COUNTY OF SAN LUIS OBISPO DEPARTMENT OF PUBLIC WORKS

1. A-2: Supplemental Notice of Preparation and Comments/Responses Need another SOP to evaluate new information not provided by SLO County for OPR.

Figure 2-1. Sanitary sewer system components and exfiltration sources.

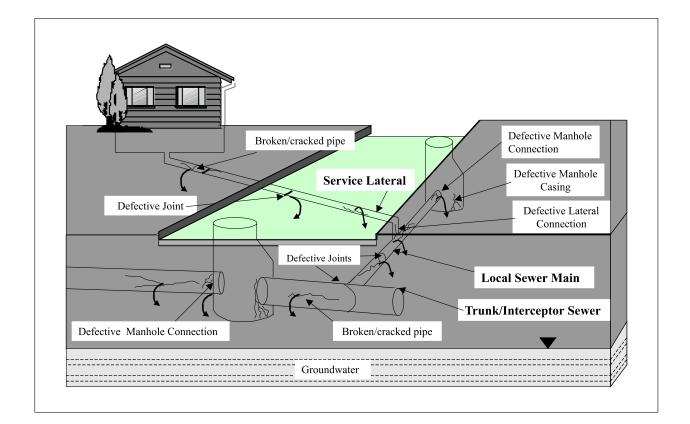
- 13.600r01034 attachment: pg 4 show where leakage in gravity collection systems are found...almost all joints to manholes lateral, trunks and mains. They leak a lot, what is your plan to fix them at what cost? It's time to be honest and transparent.
